Remarks

Reference is made to the marked-up drawings. Entry of the replacement sheet drawings is respectfully requested.

Fig. 3

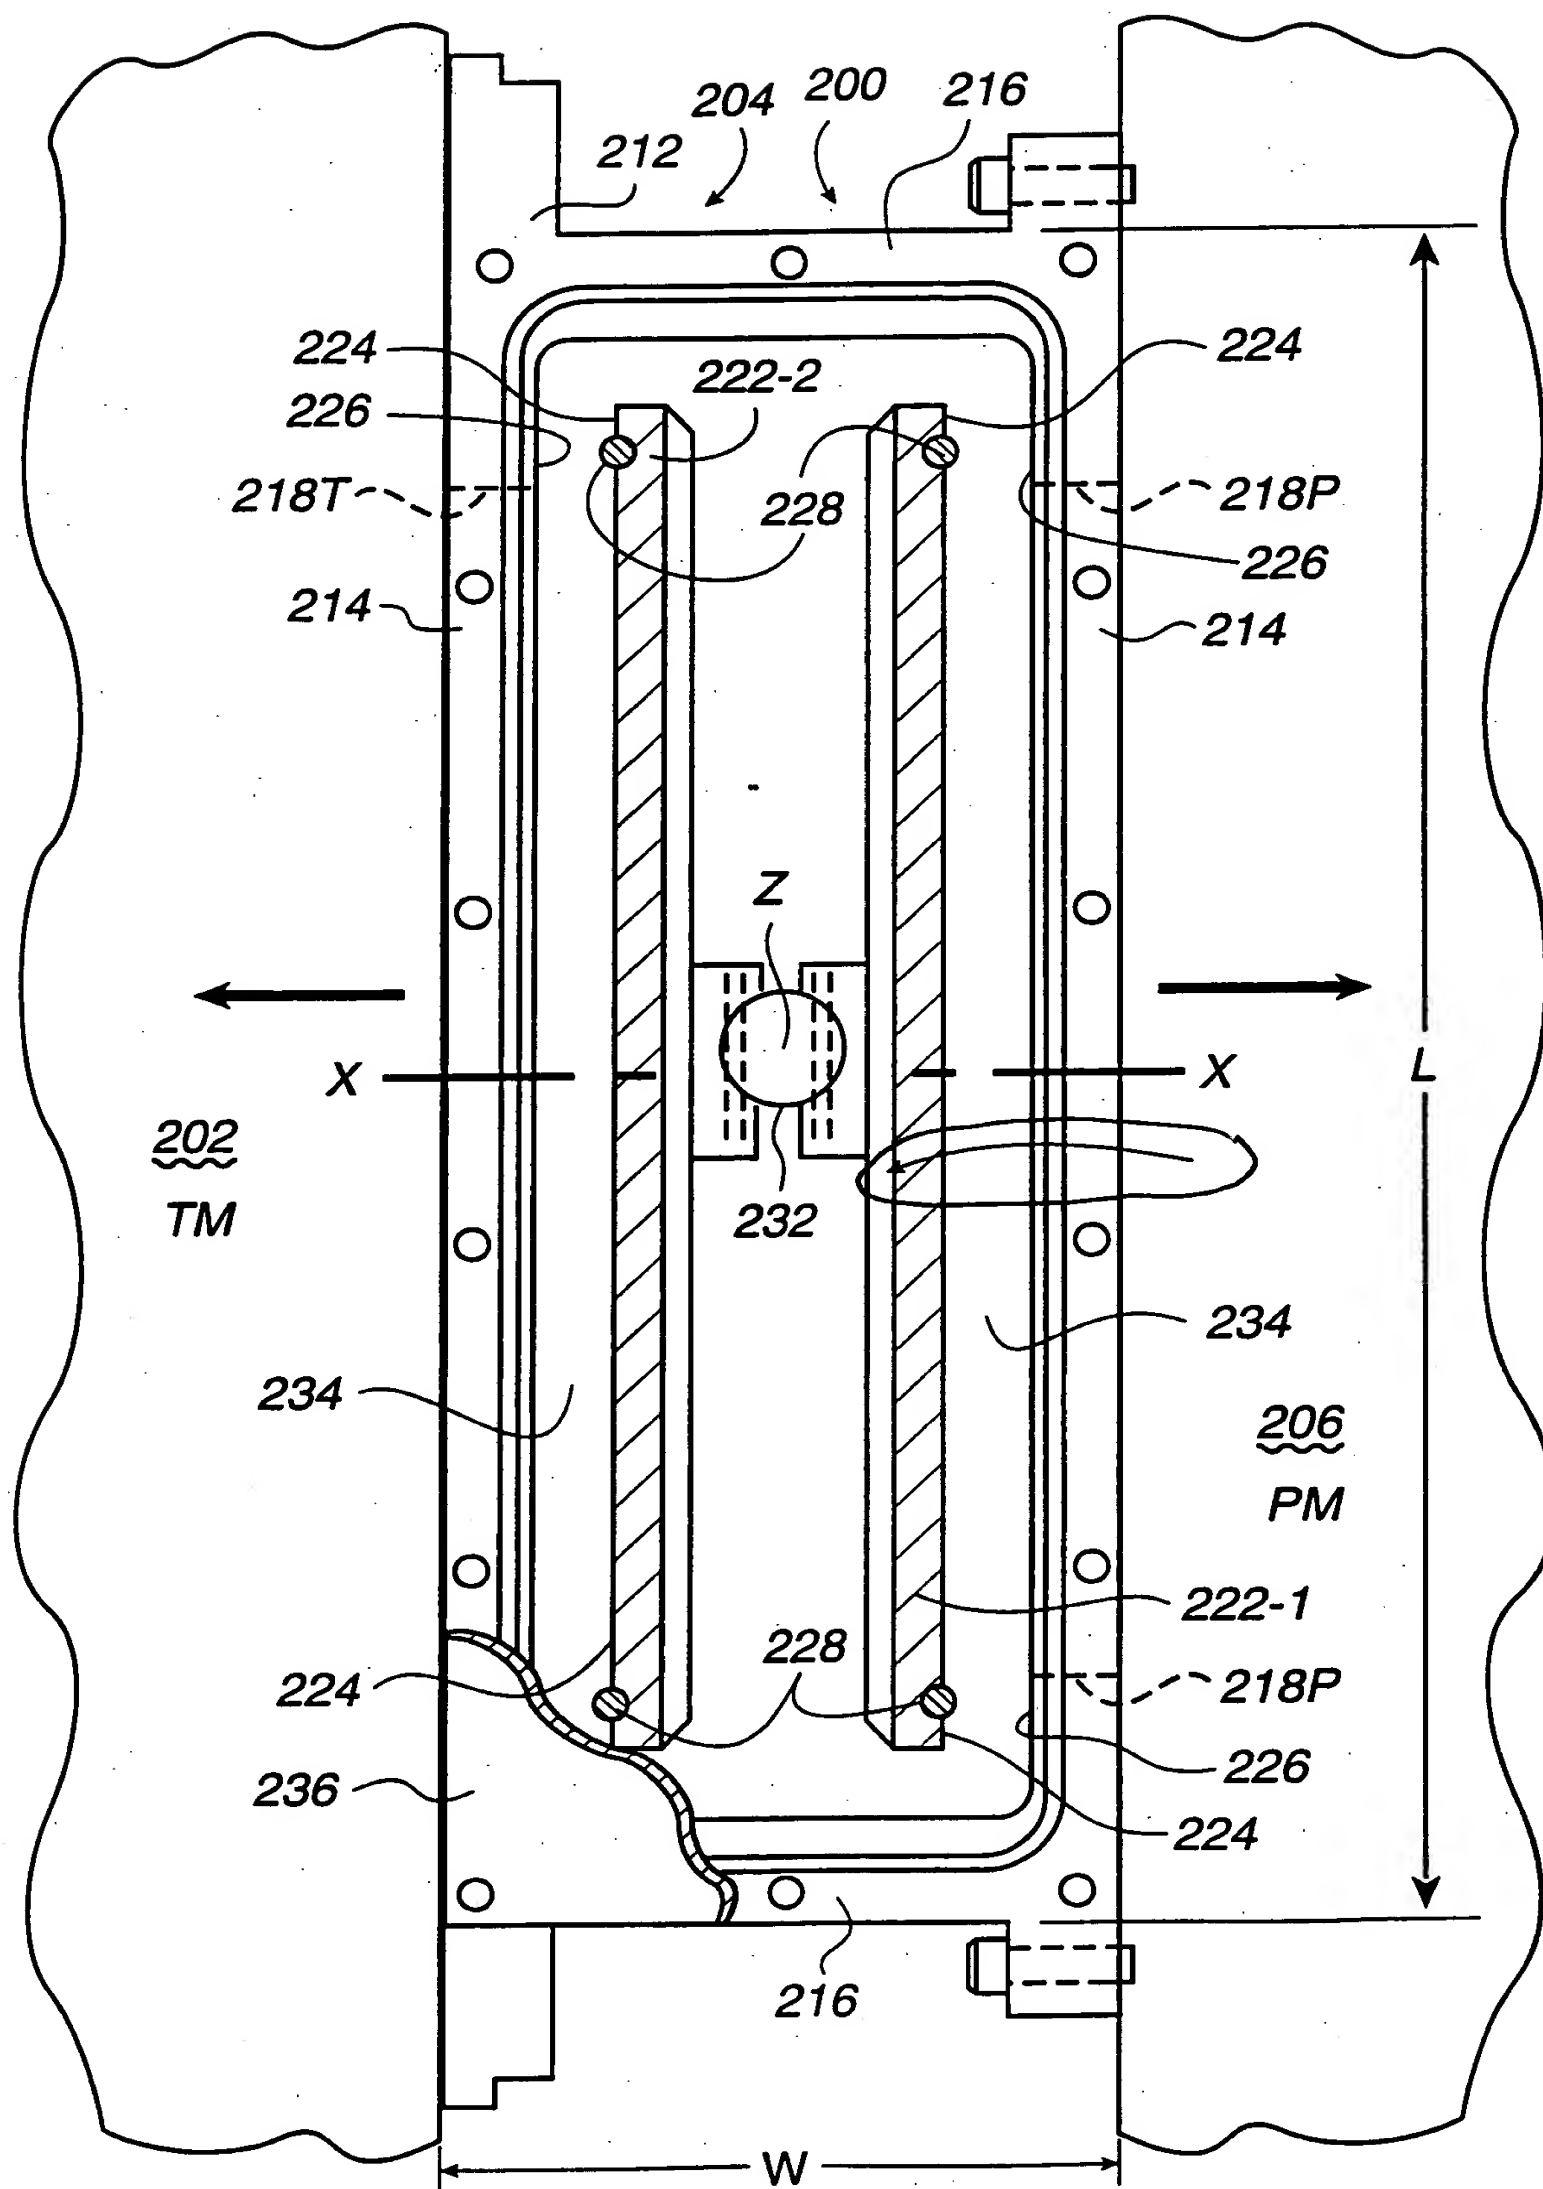
Fig. 3 identifies (by an oval) a lead line that has been removed because no reference number was denoted by the lead line.

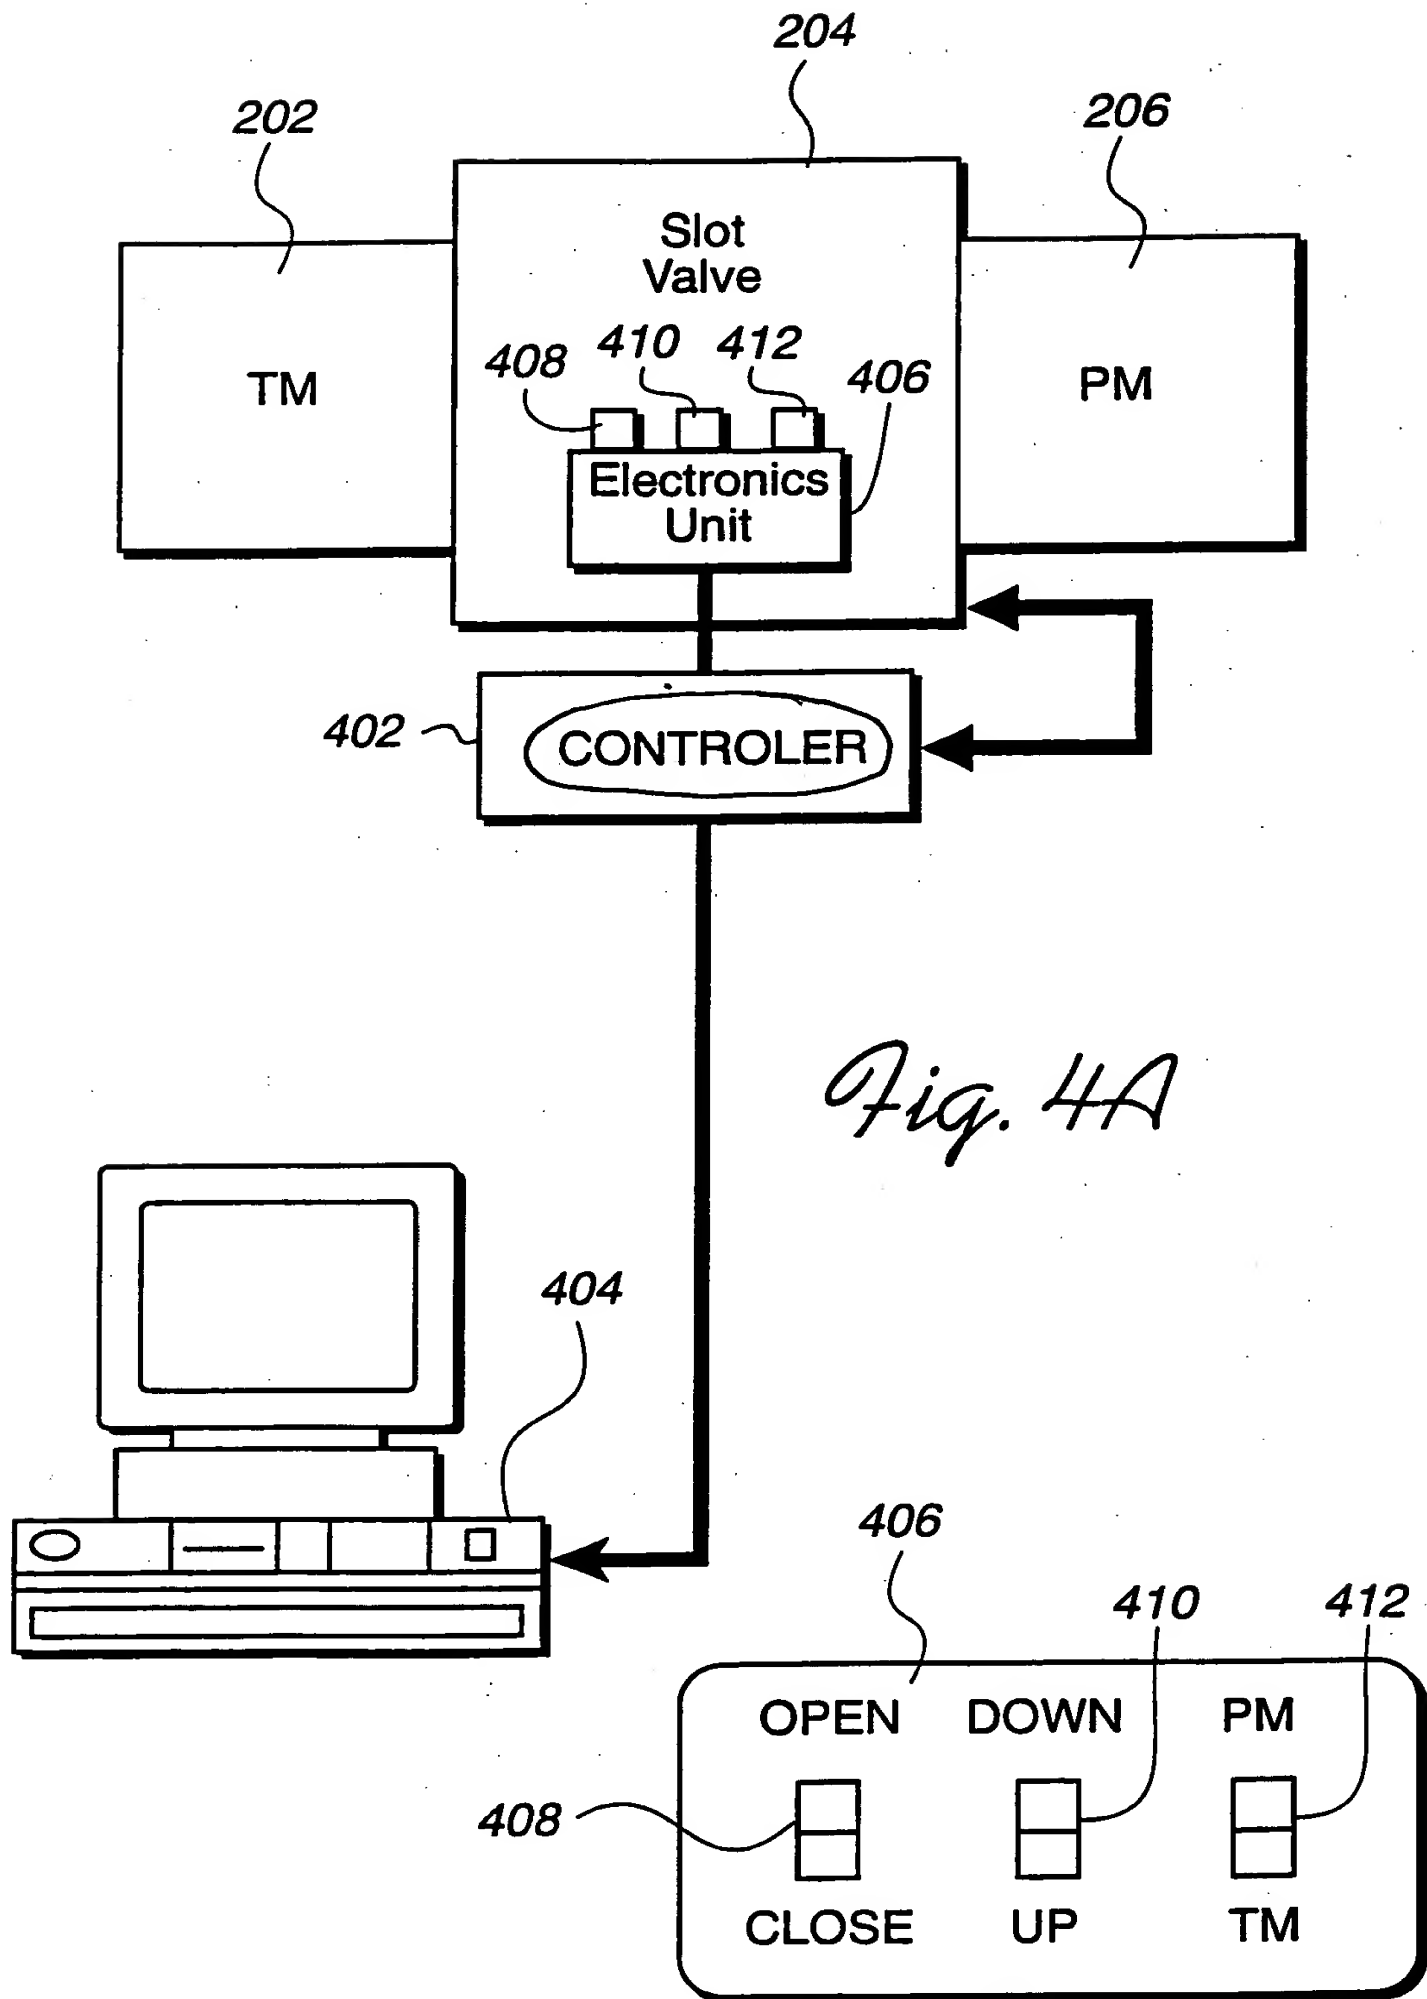
In Figure 4A, an oval identifies the word "CONTROLLER" the spelling of which has been corrected.

Fig. 5

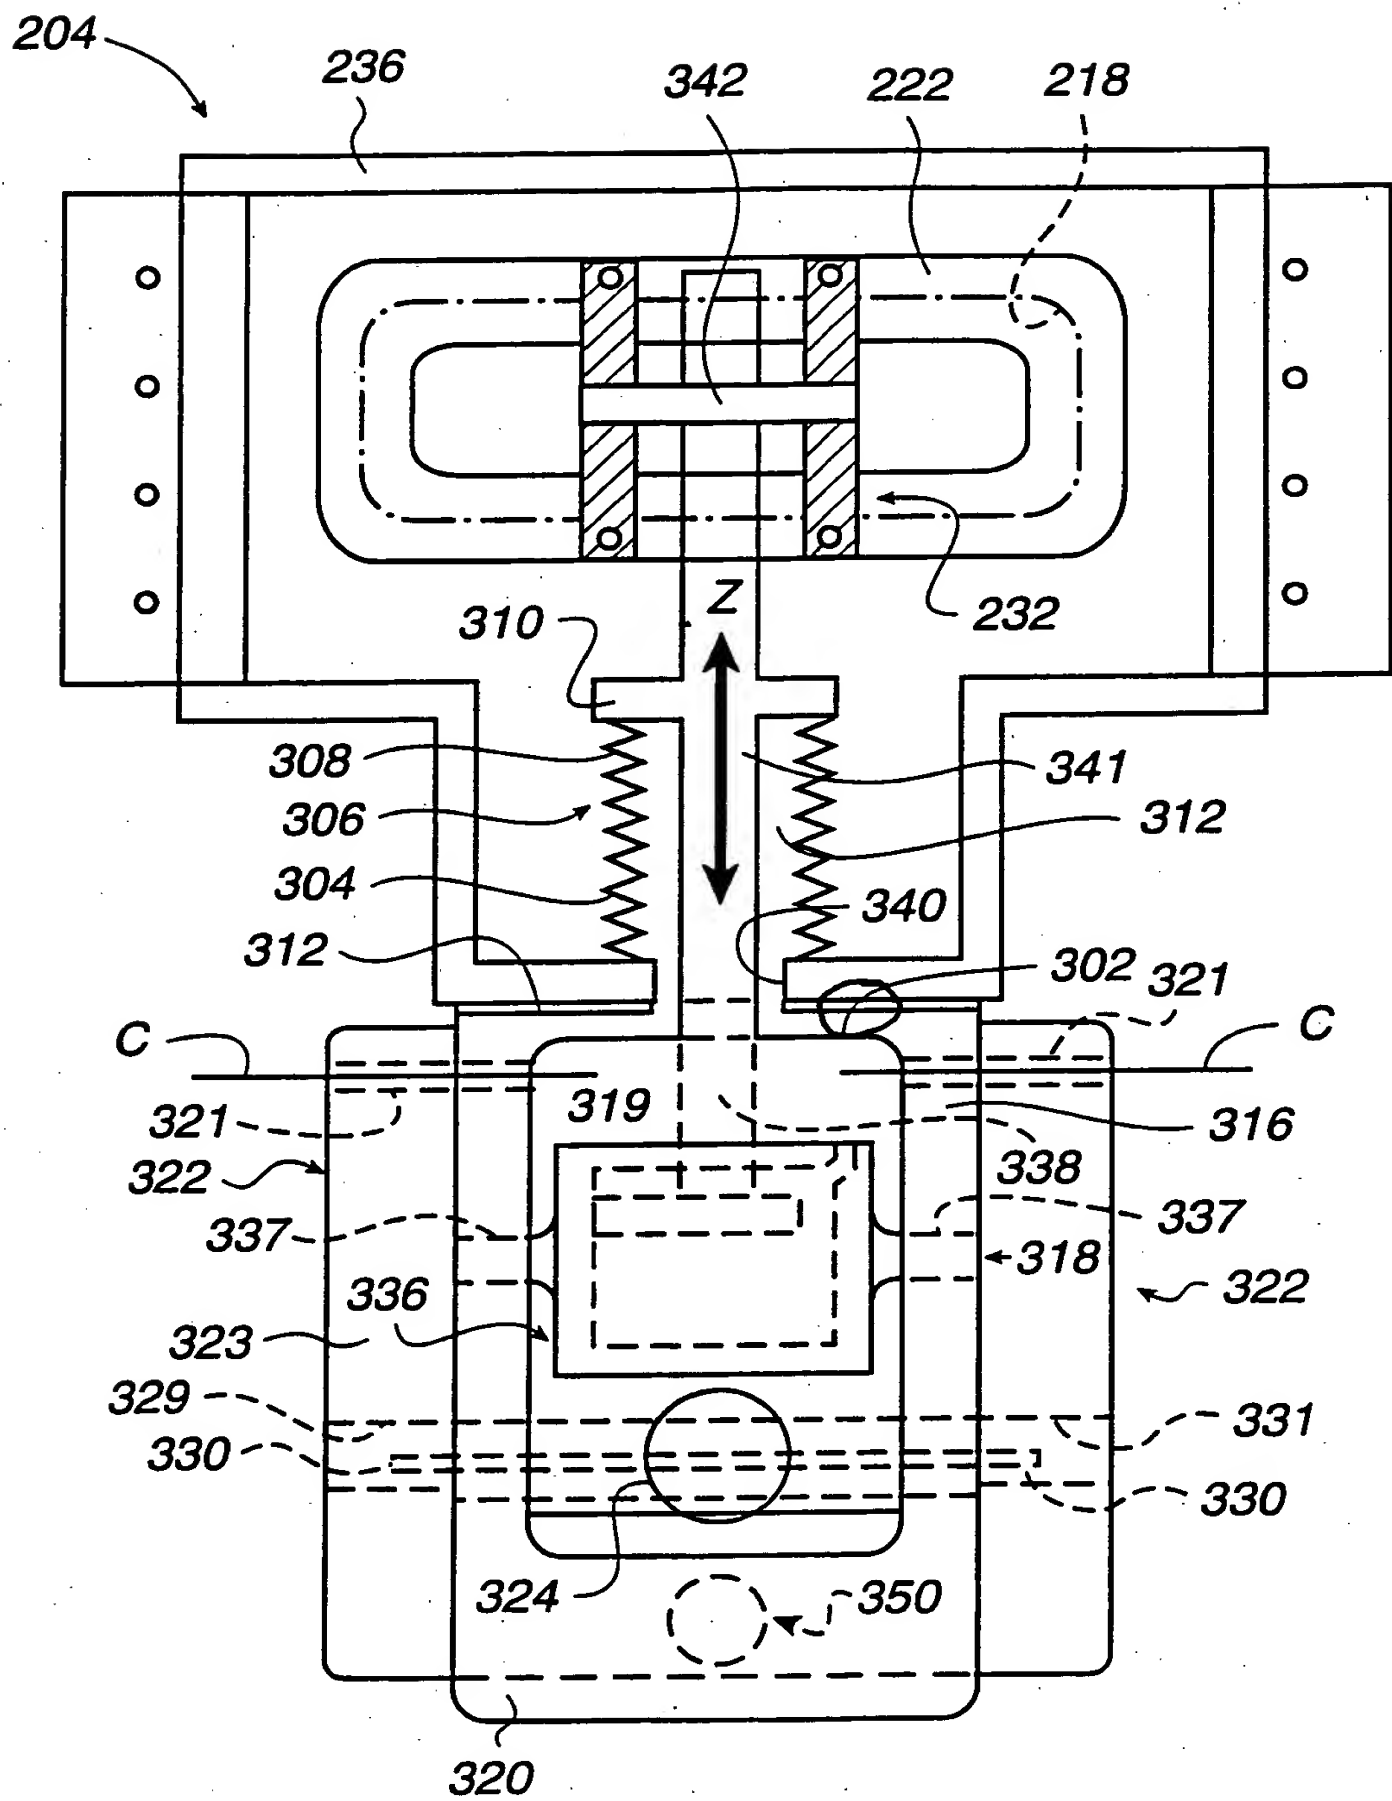
In Figure 5, a circle identifies a portion of a lead line that has been deleted, so that Figure 5 conforms to Figure 6A.

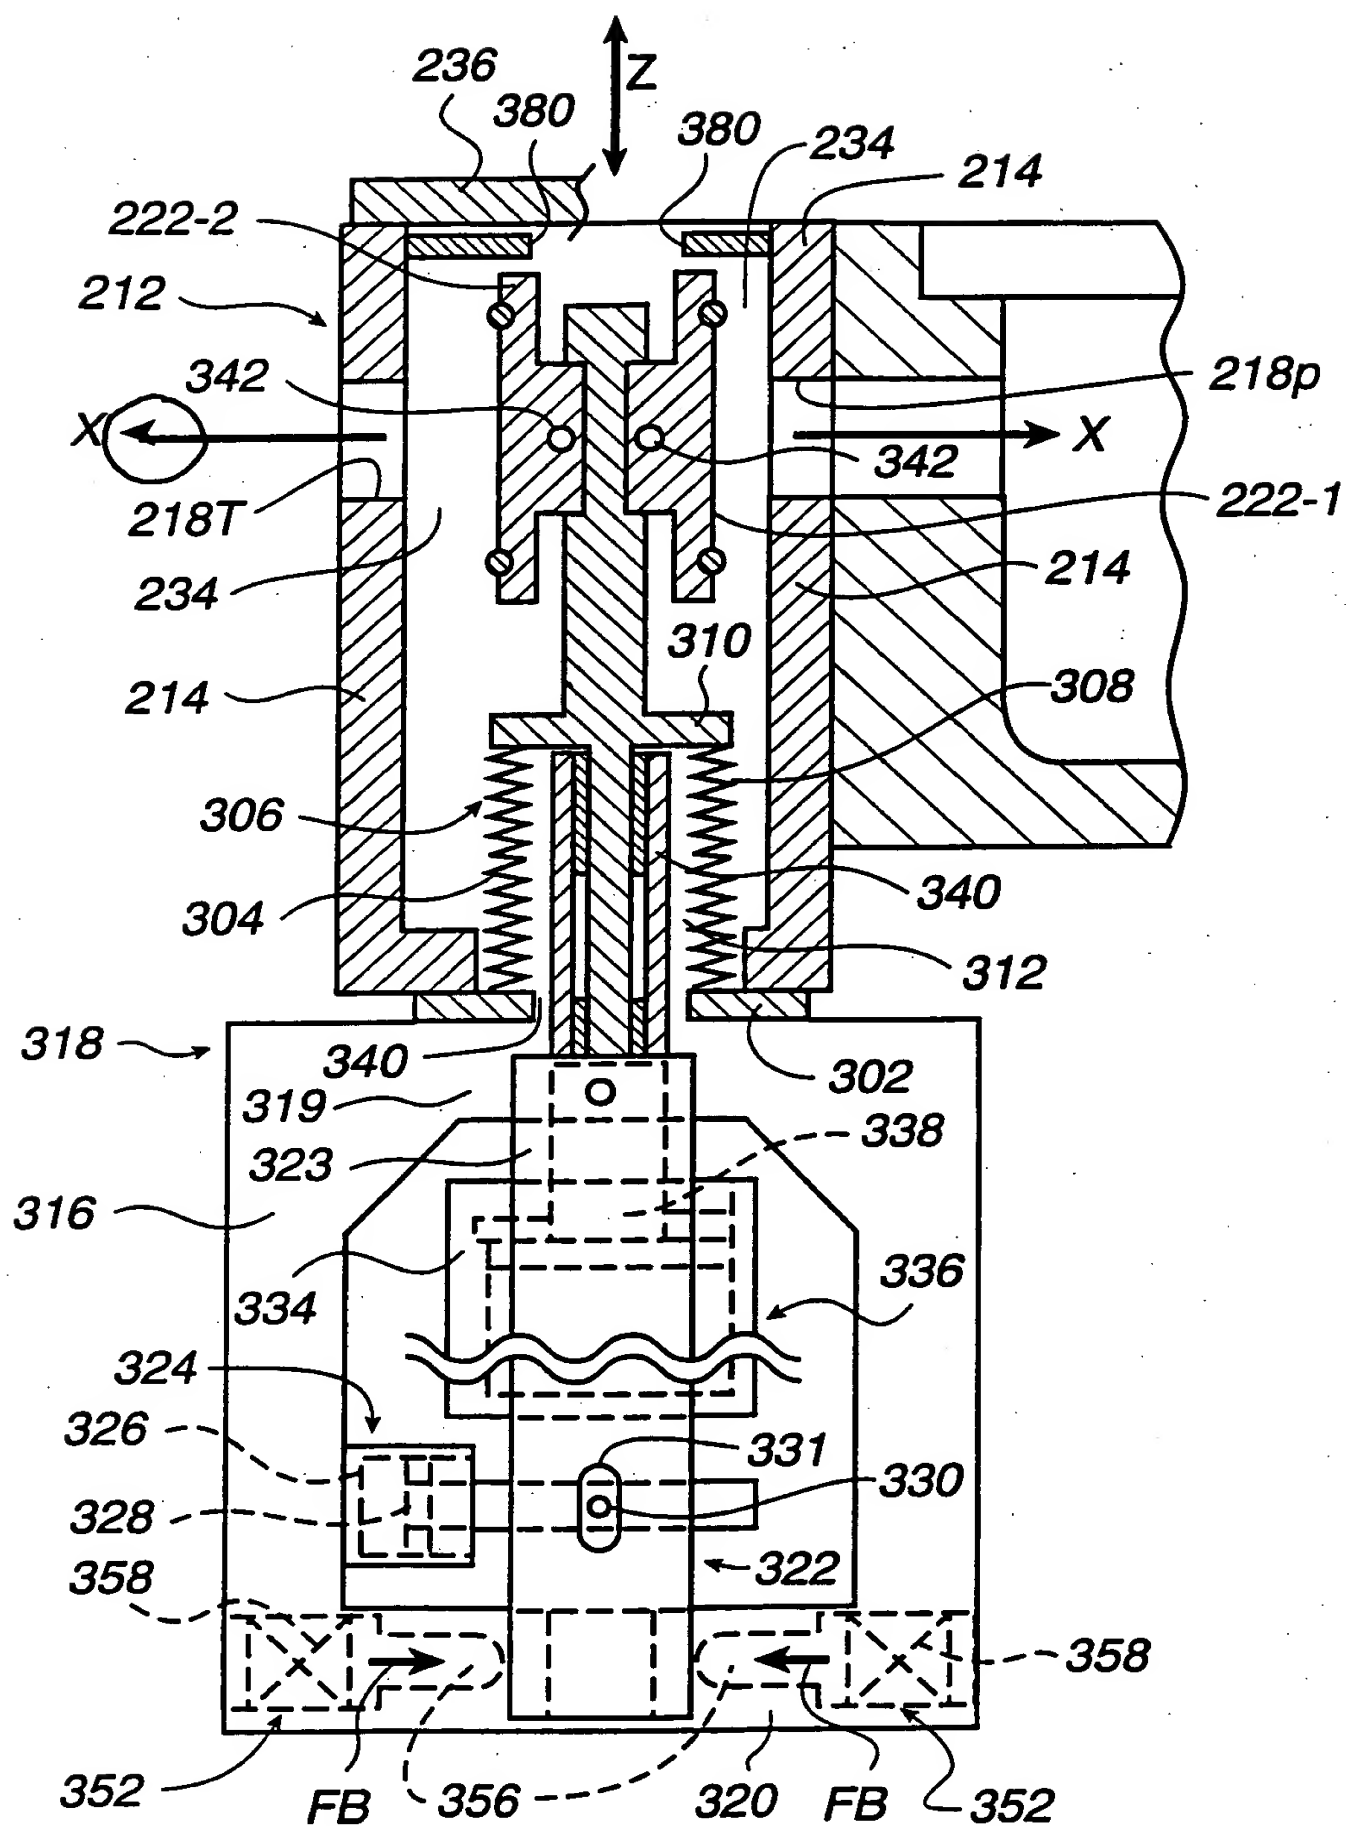
In Figures 6A and 6C, a circle in each Figure identifies an arrowhead that has been corrected.
